Staff Report

To: Salt Lake City Planning Commission
From: Michael McNamee, Associate Planner
michael.mcnamee@slcgov.com or 801-535-7226
Date: May 11, 2022
Re: PLNPCM2021-01306, Black Pearl Planned Development

Planned Development

PROPERTY ADDRESS: 968 W Quayle Ave
PARCEL ID: 15-14-405-008-0000
MASTER PLAN: Westside
ZONING DISTRICT: CG (General Commercial District)

WEST ELEVATION

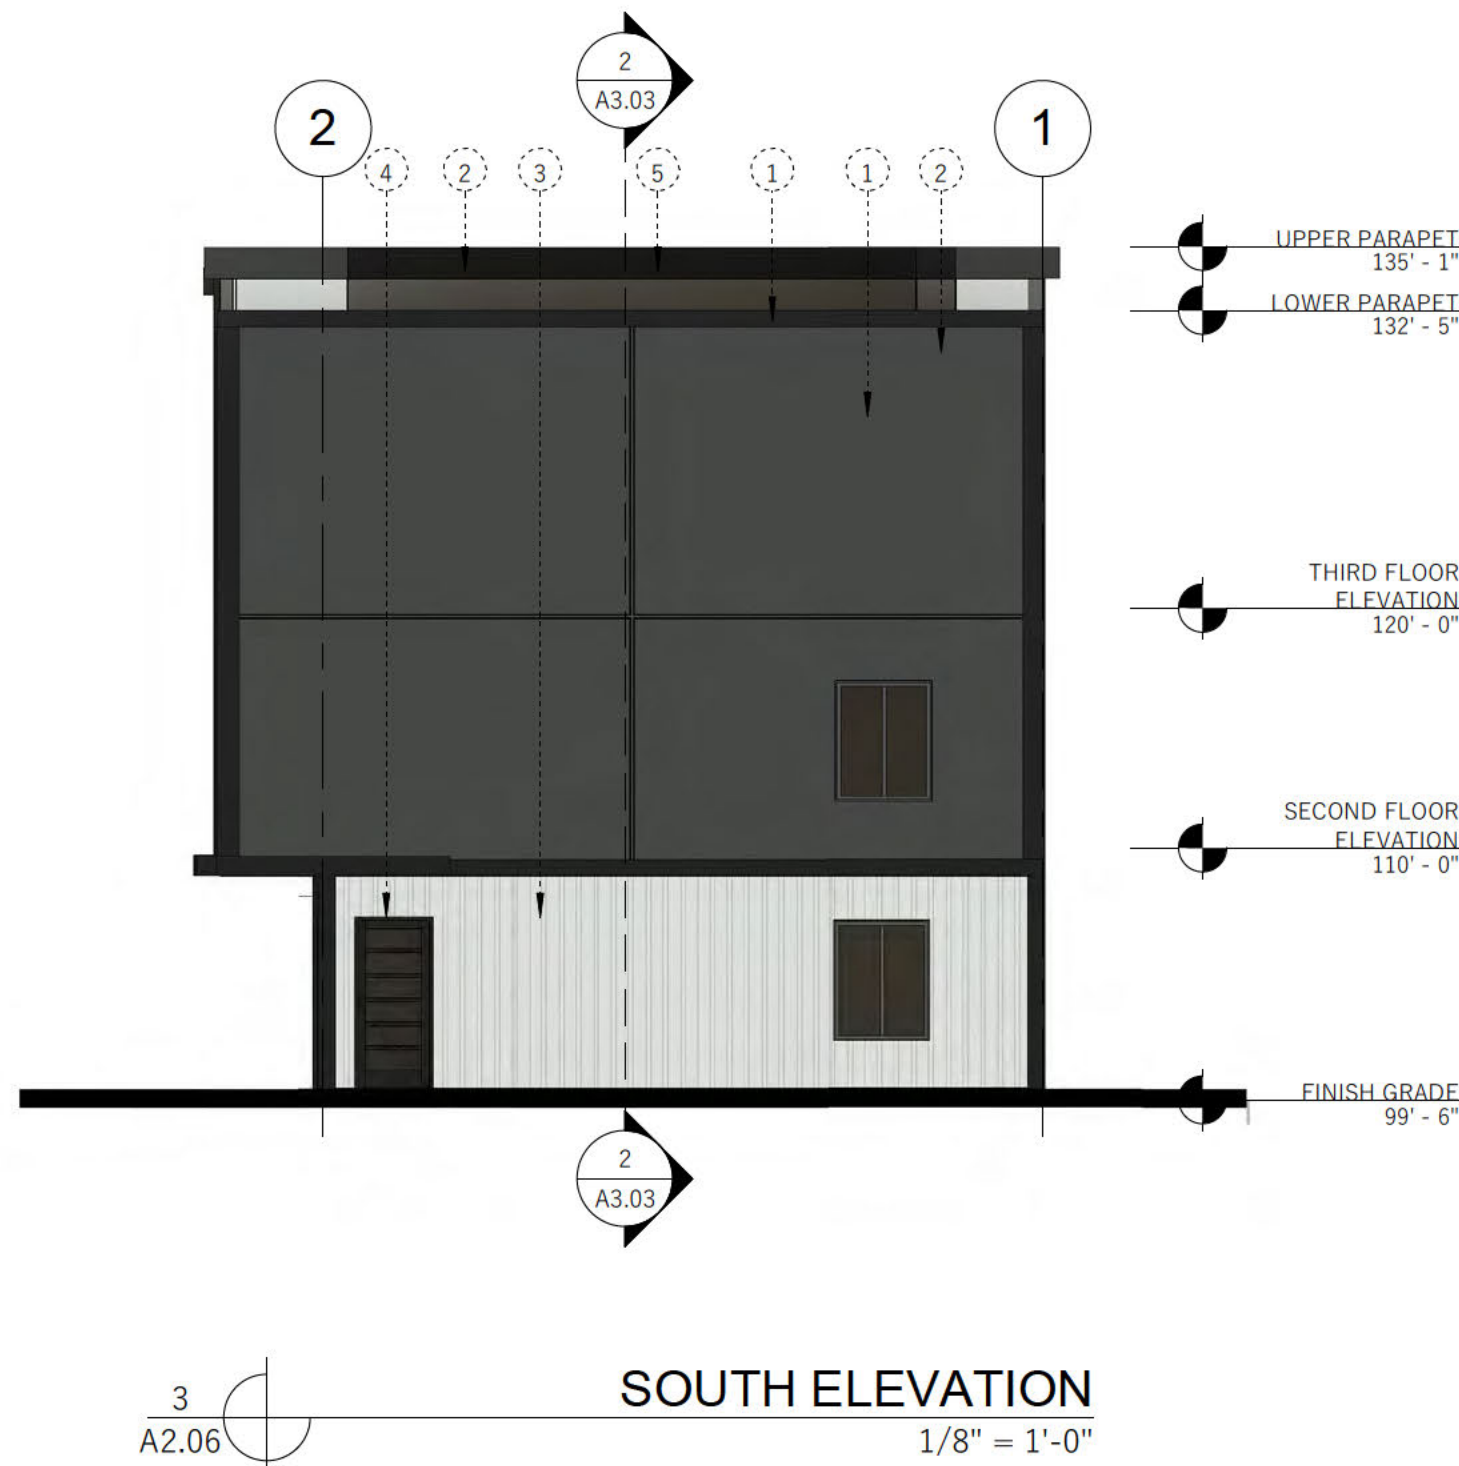
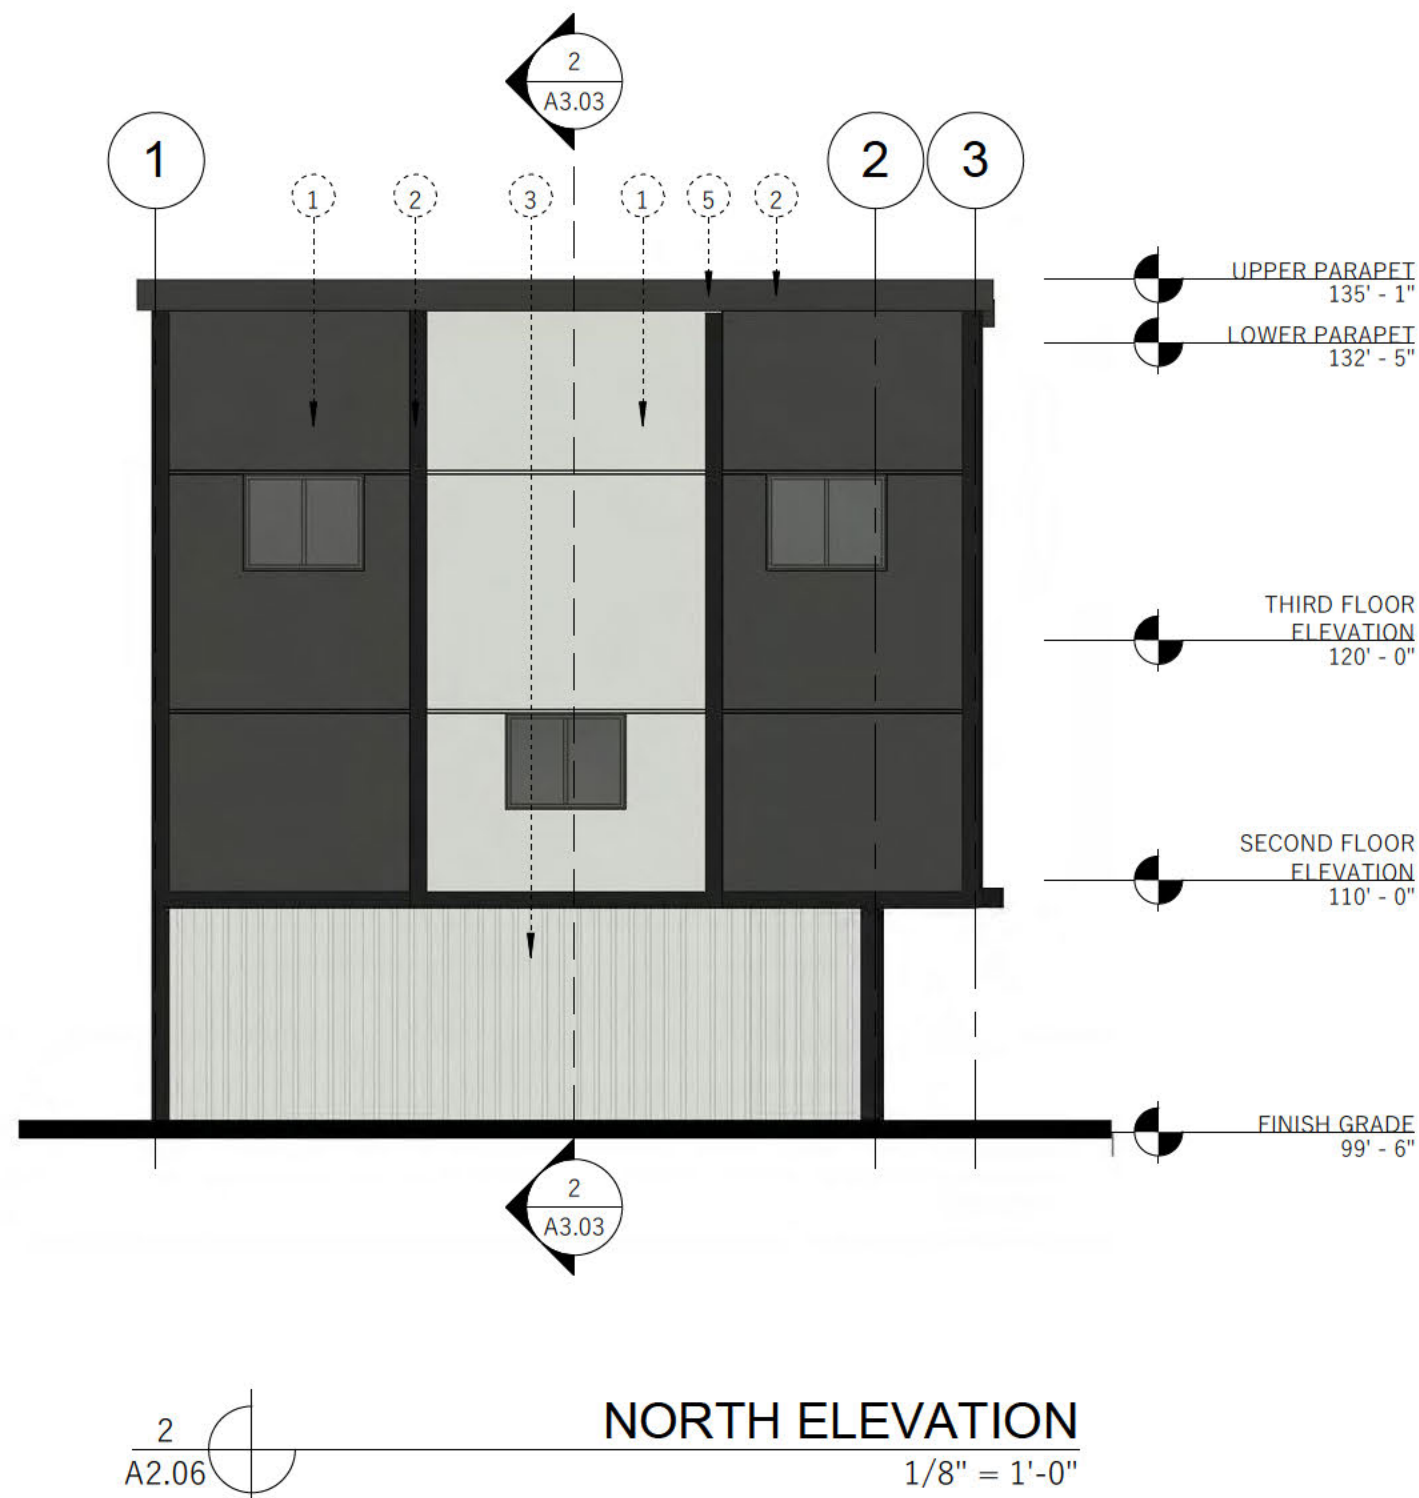
The applicant is requesting a modification that will allow them to provide front-loaded garages facing Pearl Street. This will result in a ground-level façade that consists primarily of garage doors, running counter to Planned Development standard C.4:

Granting this request will allow the applicant to build a design that offers very little in terms of ground floor transparency or architectural detailing to facilitate pedestrian interest and interaction. The façade will be primarily oriented towards the automobile, and as a result the residents and visitors will likely primarily interact with the front of the property in their cars, and pedestrian activity in general will not be encouraged. If this project were built to meet zoning standards, the drive access would need to be built to the rear of the property, greatly reducing the number of curb cuts and orienting the front of the project towards the public realm.

Building façade is primarily composed of garage doors at the ground level. Small windows in garage doors will provide some transparency into garages. Entrances to each unit are also located on the front façade and are proposed to include large sections of glass. However, these entrances are very small in scale compared to the garage doors. Design overall does not facilitate pedestrian interest and interaction.
